TRANS/WP.29/GRSG/2002/5
29 July 2002

PROPOSAL FOR DRAFT AMENDMENTS TO REGULATION No. 36

(Large capacity passenger vehicles)

Transmitted by the Expert from Germany

"Figure 10

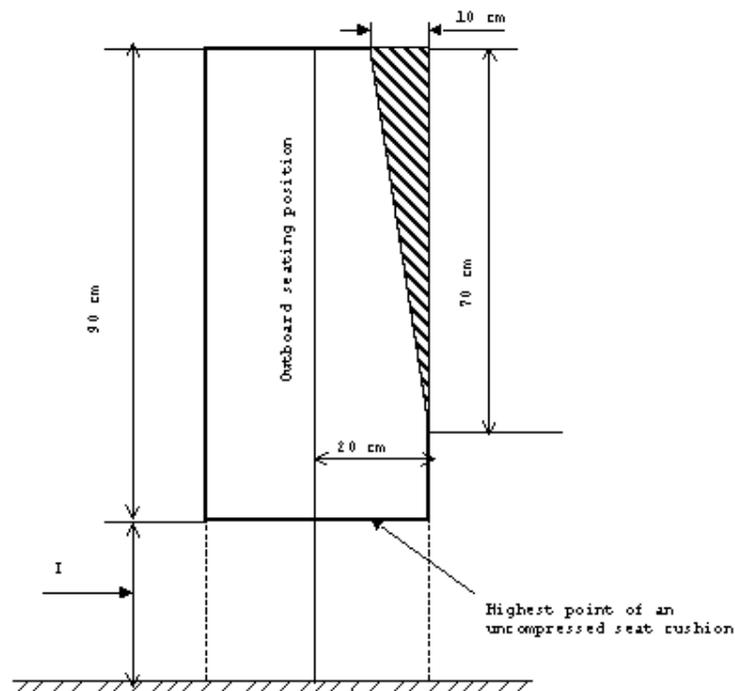
"5.7.8.6.2.2. Intrusion of a structural member provided that the intrusion is included within a triangle whose peak is situated ~~65 cm~~ **70 cm from the top** and whose base is 10 cm in width and situated in the upper part of the space in question, adjacent to the side wall of the vehicle (see annex 3, figure 10)"

Annex 3, Figure 10, amend to read:

The alteration corrects figure 10. The requirements of figure 6 for the "I" value are also transferred to figure 10 to make clear that the general prescriptions of paragraph 5.7.8.3. also apply to paragraph 5.7.8.6.2.2.

As there are different values for "I" the former method to define the starting point for the triangle representing the permitted intrusion needs to be revised, in order to establish equal conditions for all of the different values. Measuring from the top of the minimum height above the seat and leaving the geometry of the triangle unchanged achieves this.
